Southern Nuclear Operating Company
Vogtle Early Site Permit Application
Response to Safety Evaluation Report Open Items

NRC Safety Evaluation Report Open Items

on the Vogtle ESP Application

Figure 2.5-5A. Comparison of Charleston Source Zone Models

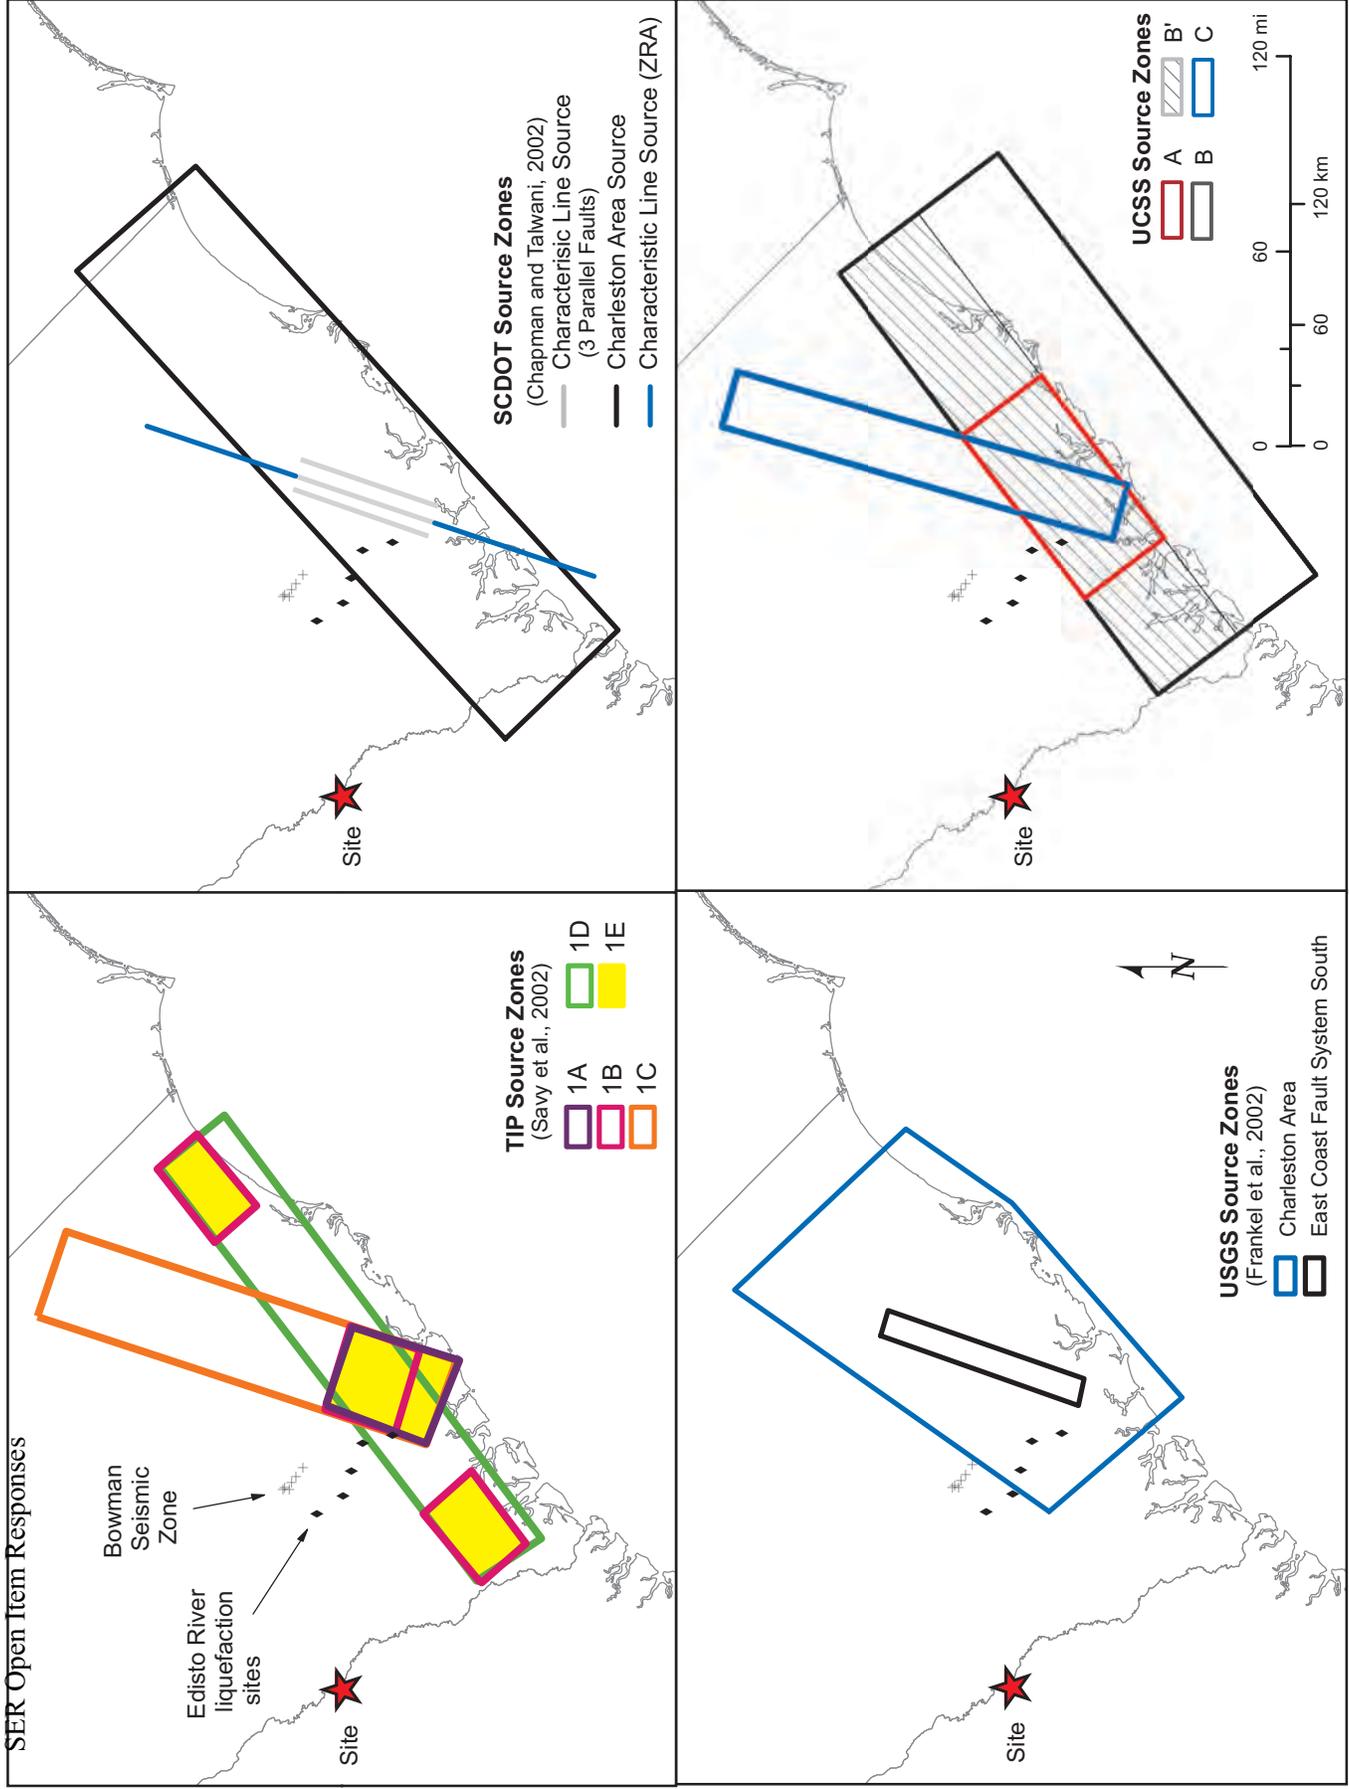
2.5-5 Provide supporting evidence to rule out the occurrence of large inland earthquakes.

The UCSS model used to describe the Charleston seismic source in the Vogtle ESP application is similar to three other, recent Charleston source characterizations that restrict (with a weighting of 80-100%) the occurrence of Charleston-type earthquakes to coastal South Carolina where the preponderance of data support recurring large earthquakes.

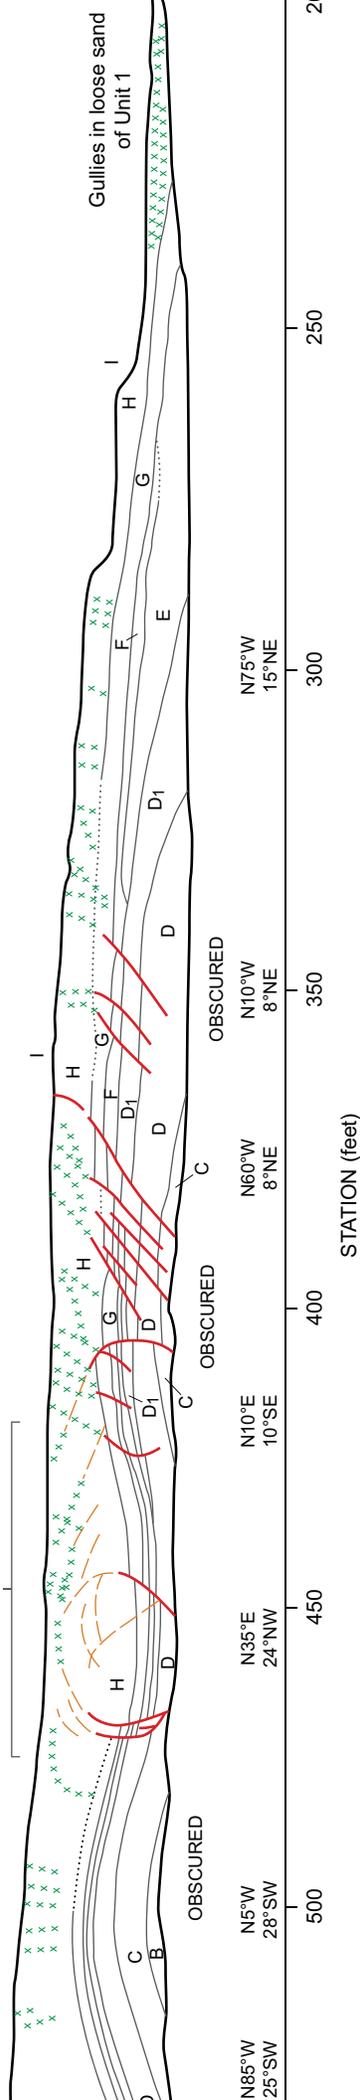
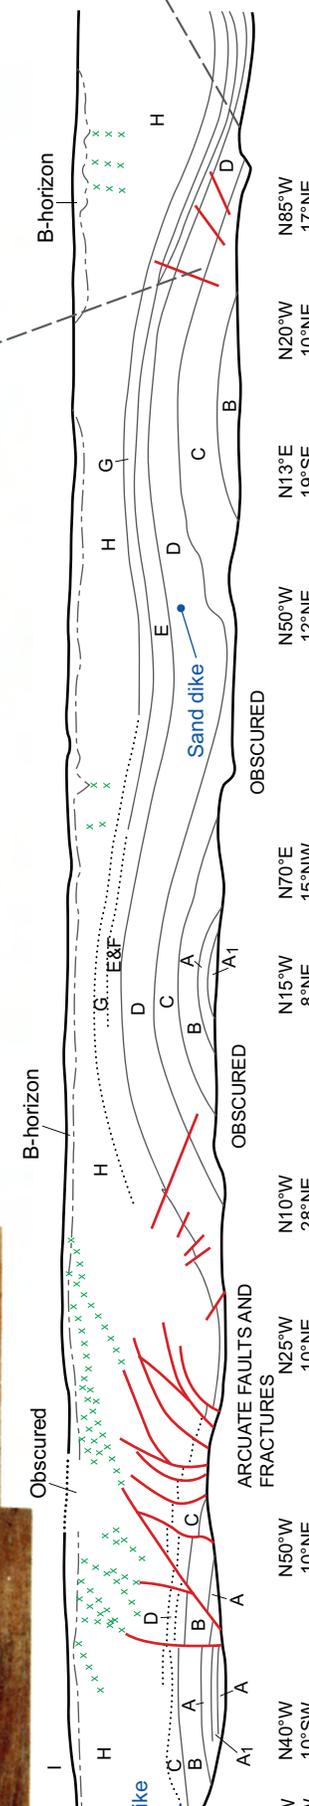
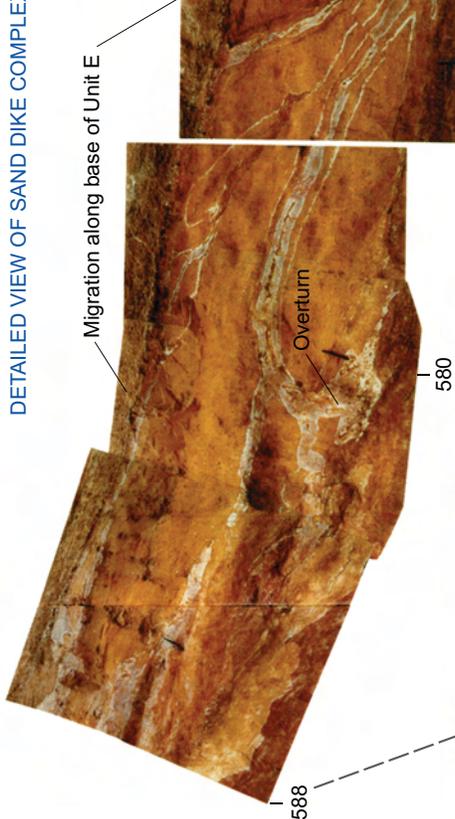
2.5-10 Provide a more detailed description of the geometry and appearance of the injection sand dikes and their spatial association with dissolution depressions (including photographs of this feature, if available).

The injected sand dikes occur at three localities in the Bechtel (1984) trench (Figure 2.5-10A). These sand dikes were not observed at any other location either on or off the VEGP site during the ESP mapping effort. Within the trench, the sand dikes are only located within the upper Eocene Barnwell Group and as identified by Bechtel (1984), consist of lavender, loosely consolidated, well sorted, very fine, clean quartz sand and are confined to a single unit (Unit D) within the trench. These dikes were likely formed by fluid or plastic injection of sand from a source in underlying sand beds of Unit C. The sand dikes are locally mapped along the up-dip contact with Unit E, but do not penetrate Unit E (Figure 2.5-10A). As the dikes were mapped downward, they became irregular and indistinguishable as they entered/emerged from Unit C (Bechtel, 1984).

As described in Bechtel (1984), the orientation of the dikes varies greatly. At each location they dip steeply down the limbs of large depressions and appear to have a source within Unit C at the base of the depression. The dikes flatten upward toward the crest of arches (Figure 2.5-10A).

The sand dikes are plotted on the contour and 3-dimensional surface grid from Bechtel (1984, Figure 5) (Figure 2.5-10B). As shown on Figure 2.5-10B, the upper Eocene Barnwell Group is deformed into a series of irregular depressions that form an ‘egg-carton’ or ‘dimpled’ pattern. The depressions are not aligned or elongated in any preferred orientation, and are most likely the result of dissolution of the underlying Utley limestone and collapse of overlying strata. The injected dikes are concentrated in the area of greatest ‘dimpling’ and are absent from the area of least ‘dimpling’. Bechtel (1984) identified only one large complex of sand dikes and this complex plots in a depression (Station 570 to 590, Figure 2.5-10B). The remaining two, single, laterally discontinuous, thin sand dikes plot along margins of depressions (Stations 642 and 830, Figure 2.5-10B). The close spatial association of the sand dikes with limbs of the depressions suggests that the liquid injection resulted from development of the depression. Subsequent deformation and faulting of the sand dikes (for example at Station 575) show that the sand dikes pre-date later phases of sediment collapse and formation of the depressions.
